Warringah Council

JRPP No:	2011SYE042
DA No:	DA2011/0400
Description:	Demolition works, construction of an infill affordable housing development under SEPP (Affordable Rental Housing) 2009 and strata and stratum subdivision
Address / Property	Lots 25 & 26 in DP 398815, Nos. 2 & 4 Riverhill Avenue Forestville; Lots 4A in DP 358192, No. 751 Warringah Road Forestville and Lots B, A & C in DP 368072, Nos. 753, 755 & 757 Warringah Road, Forestville
APPLICANT:	McKees Legal Solutions (Graham McKee)
REPORT BY:	Peter Robinson, Acting Director Strategic and Development Services

Assessment Report and Recommendation

Figure 3 Scale of existing development in the area of the site

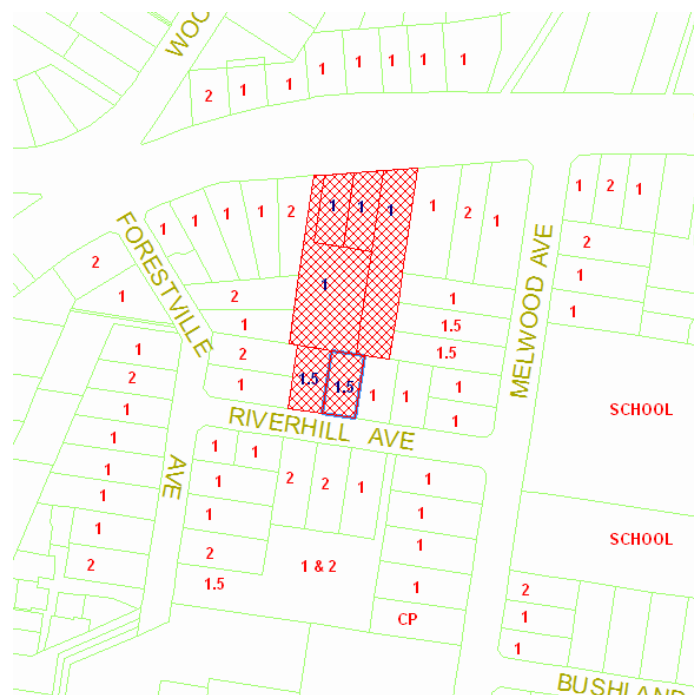
Figure 3 below illustrates the scale of surrounding development in the area by the number of storeys (as indicated in red).

The development is not consistent with Principle 2 - Scale.

Figure 6 Proposed landscaping (areas of concern indicated in red)
(Source: Adapted by the author from 'Masterplan' dated 24 March 2011 as prepared by Paul Scrivener)

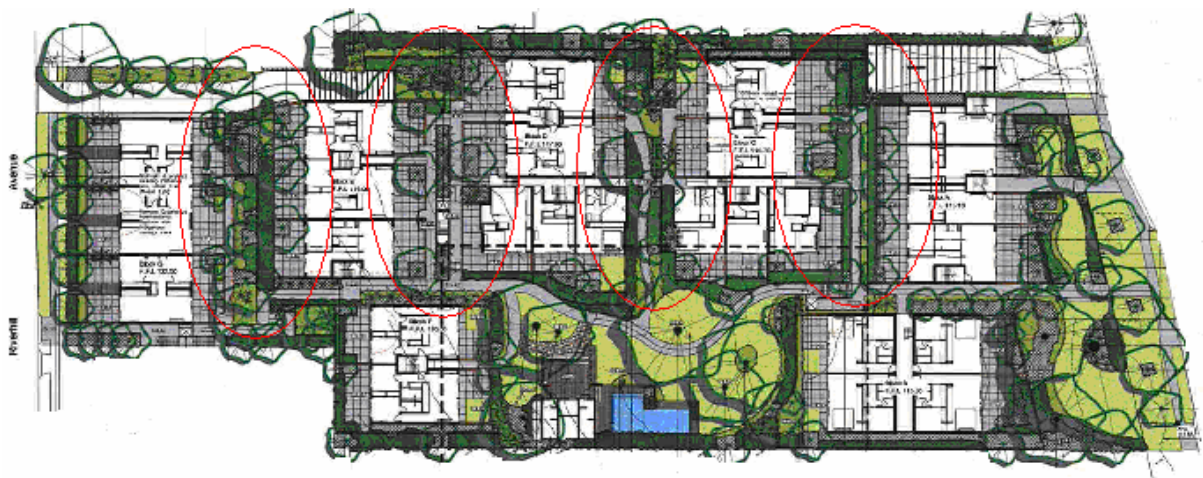
The landscape plan indicates that plantings are proposed between buildings (specifically Buildings A, C, D, E & G) but the extent of hard surface area (courtyards and pathways) limits the scale of planting to small trees and shrubs (see Masterplan dated 24 March 2011 as prepared by Paul Scrivener). Figure 6 below shows the extent of proposed planting and hardstand area throughout the site.

Council's Landscape Officer has reviewed the landscape plans and has provided comments (see Internal Referrals in this report) which raise concerns about the minimal amount of soft landscaping between the buildings in context to the size of the proposed development. In this regard, it was noted in the referral response that *"the planting proposed between the buildings is not considered to be commensurate with the building bulk being proposed"* and that *"a larger and softer landscape separation would be expected to provide a setting more in keeping with that envisaged in the DFC and under the SEPP in relation to Landscaping and Scale and Built Form."*

Figure 8 View of non-compliant building envelopes (marked in red) along the western elevation.
(Source: Adapted by author from Plan No. DA-201 dated March 2011 and prepared by CKDS Architecture)

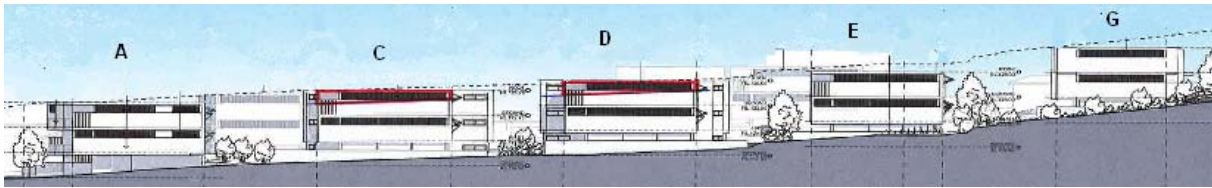
- Building B – Along the entire eastern side of the building to a depth of 1.0m to 1.3m (see Figure 7 below).
- Building C – Along the entire western side of the building to a depth of 0.5m to 0.8m (see Figure 8 below).
- Building D - Along the entire western side of the building to a depth of 0.5m to 0.8m (see Figure 8 below).
- Building F – At the front eastern corner of the building to a depth of 0.5m (see Figure 7 below).
- Building G – At the front eastern corner of the building to a depth of 0.2m (see Figure 7 below).
